# CITY OF MILWAUKIE

November 12, 2019

### DESIGN AND LANDMARKS COMMITTEE

## Downtown Design Review

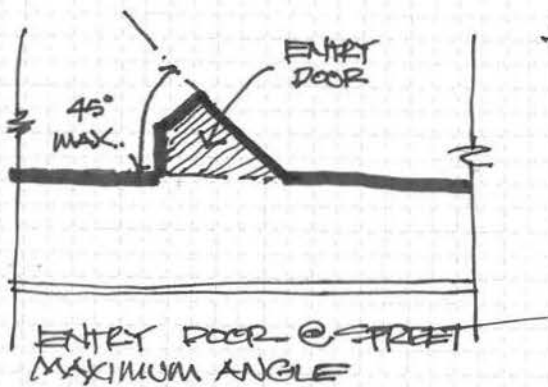
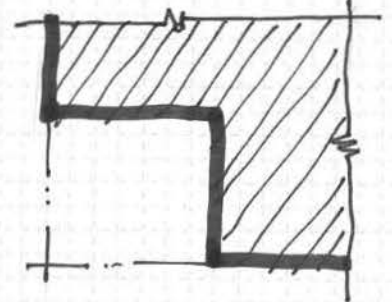
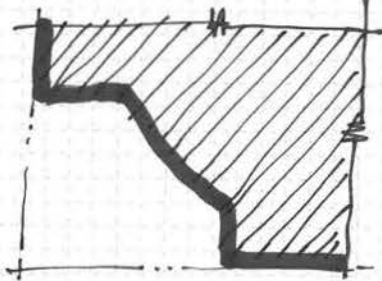
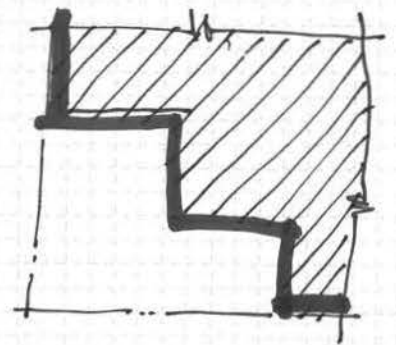
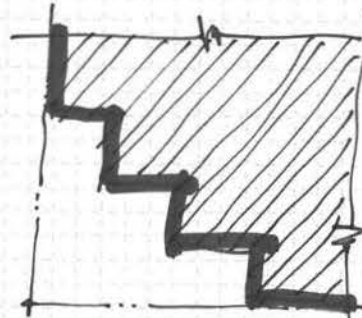
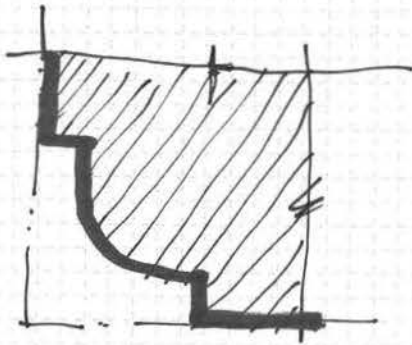
- D. An eroded corner: For example, the corner of the building cut at a 45° angle or a similar dimension “rounded” corner. See Figure xx *[Brett Laurila’s sketches]*.

#### Notes on Figures

- Make the image larger and clearer.
- For purposes of the illustration, the door should swing out.
- Use Brett Laurila’s sketches, noting that a column can be added to each scenario to support upper floors and provide cover.
